TECHNICAL BULLETIN # 49

ANSI 156.10 - 2011 Updates

SUBJECT: The purpose of this bulletin is to provide summary updates of ANSI 156.10 - 2011

Figure A 12-A

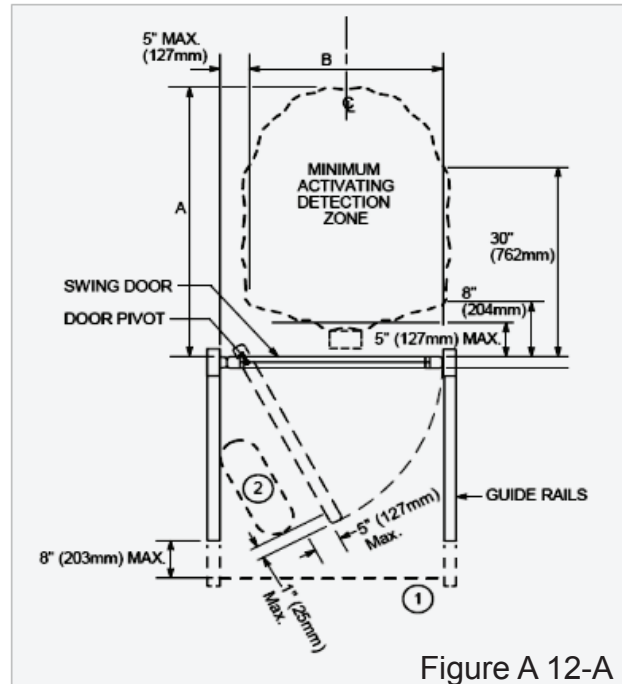
8.2.2.2.(1): When using a photo beam, the detection width shall be not less than the clear opening; the beam shall be located between 6 and 28 in. above the finish floor, and not more than 8 in. from the lead edge of the door panel in the full open position (See Figure A-12A).

8.2.2.2.(2): When using a door mounted presence sensor, the detection area shall be effective to within 5 in. from the face of the door, for one half of the width of the door, and to within 1 in. of the lead edge, and shall detect a 28 in. minimum high person fully in the defined area. (See Figure A-12A)
